NAVAL ASSESSMENT AND CONTROL
OF INSTALLATION POLLUTANTS
REVIEW WORKSHOP

NAS-JACKSONVILLE

VERIFICATION STUDY
CHARACTERIZATION STUDY

April 29, 1986

SITE NO. 40. INDUSTRIAL WASTEWATER DISCHARGE

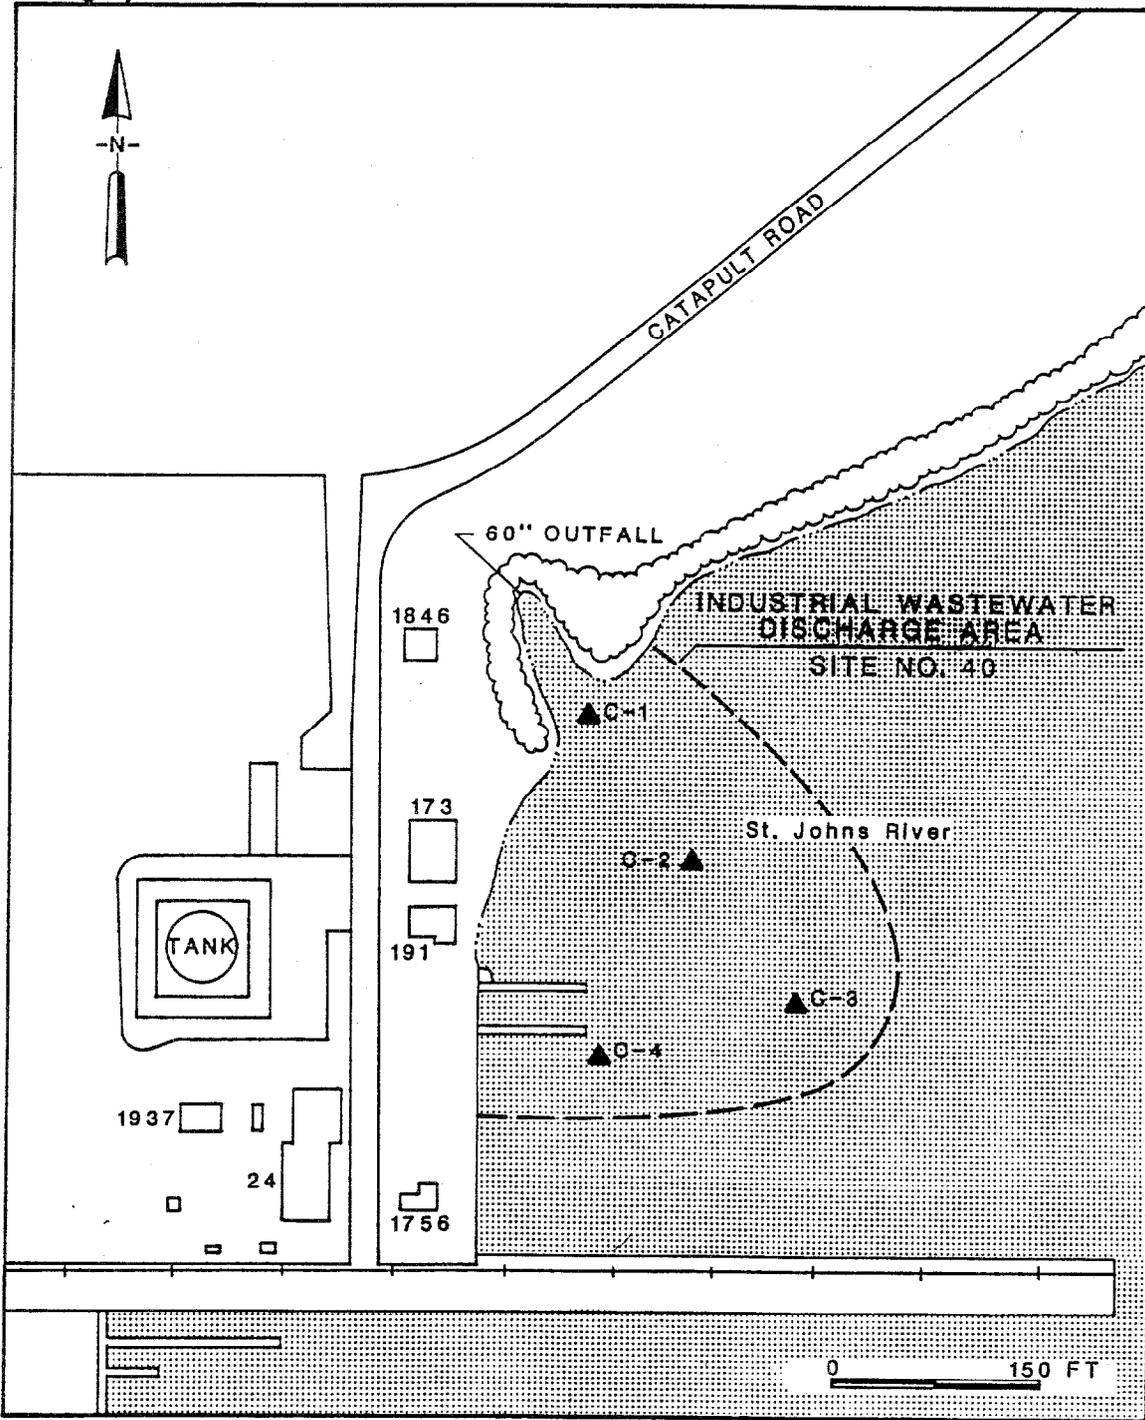
Drop it.

SITE NO. 5. NFD: OIL POND AND LAND SPREADING AREA

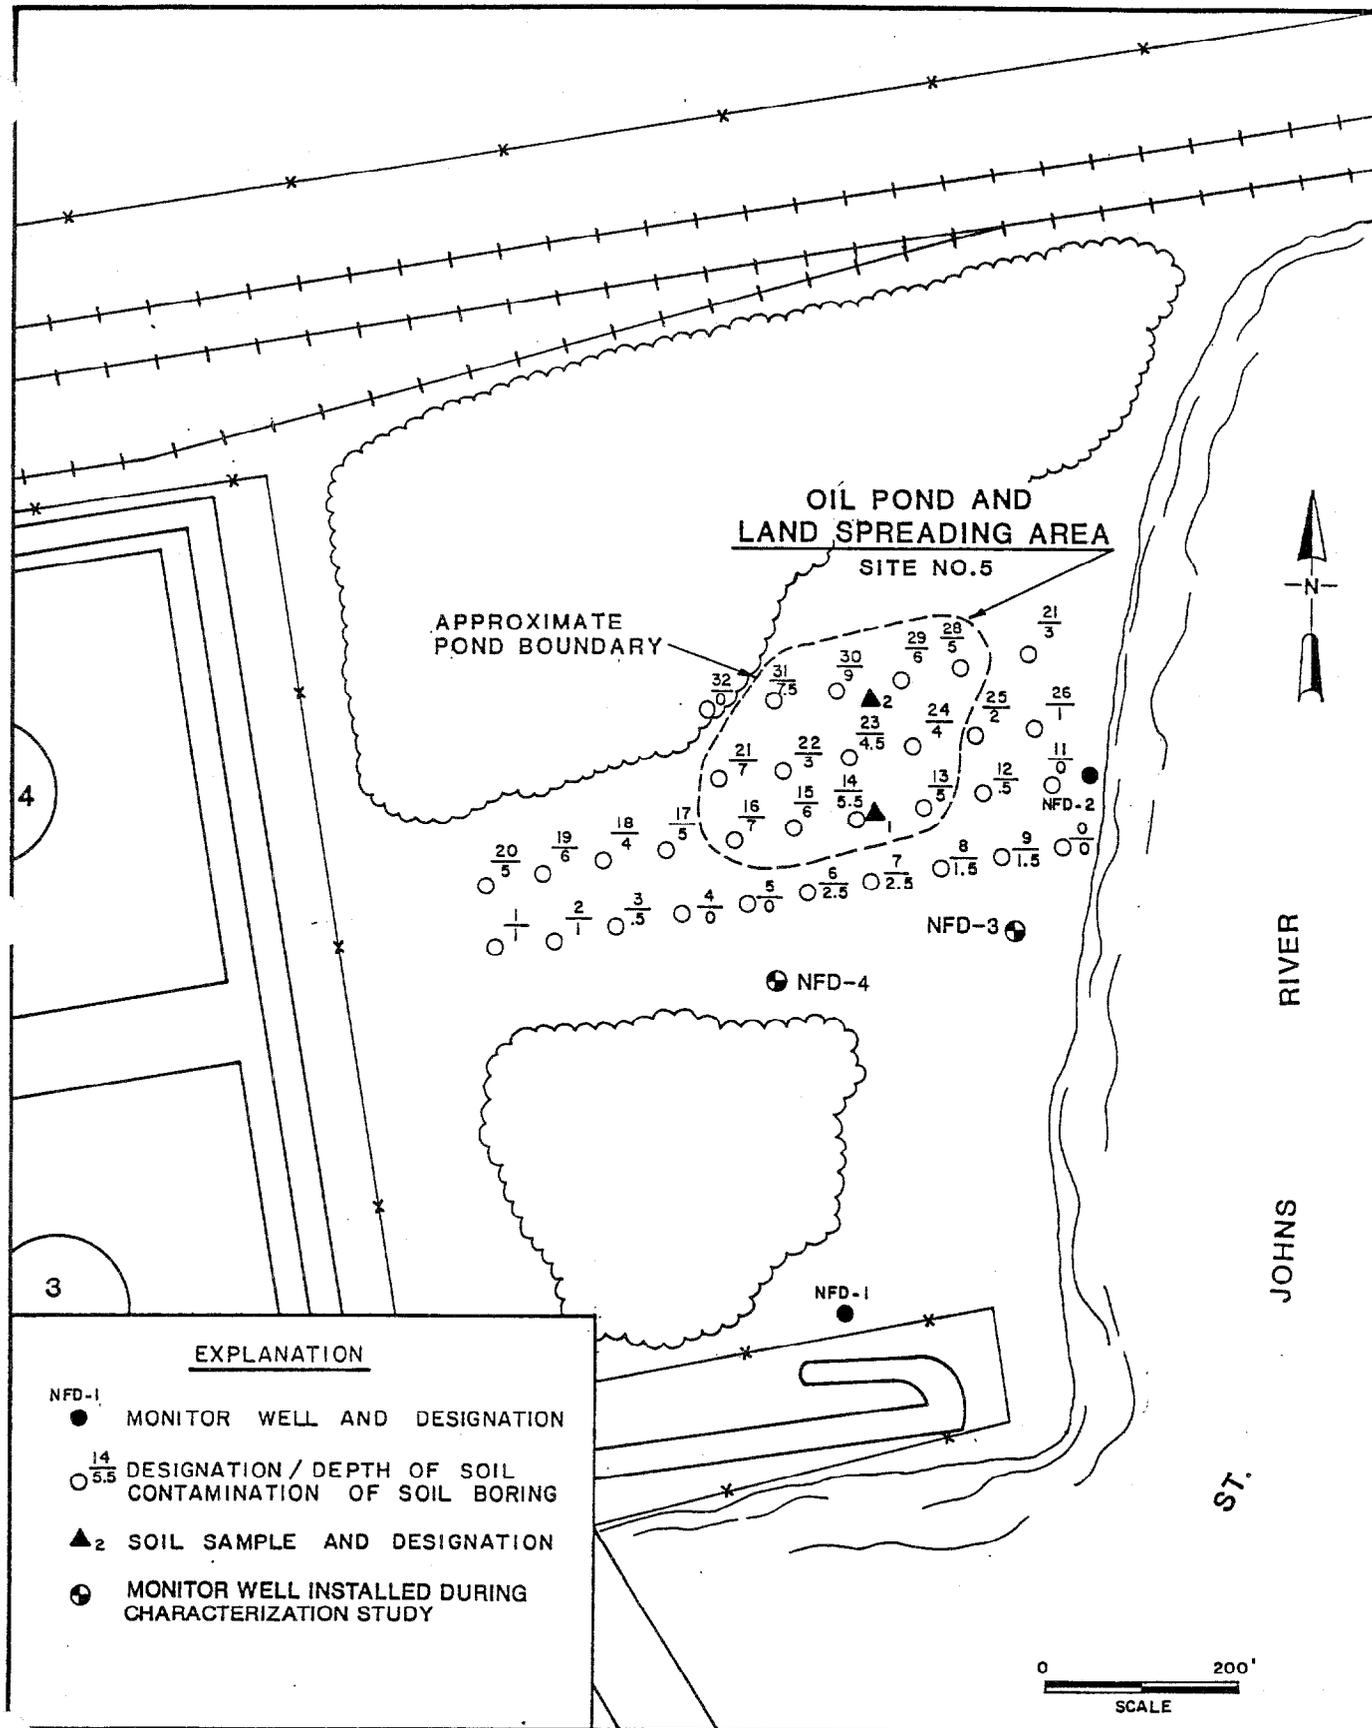
Don Bayley has no problem with this
and Mr. Crane agrees, but would like
a Ph on well #2 4-29-84

EPA 610

NFD 5 risk assessment depends on final
results.
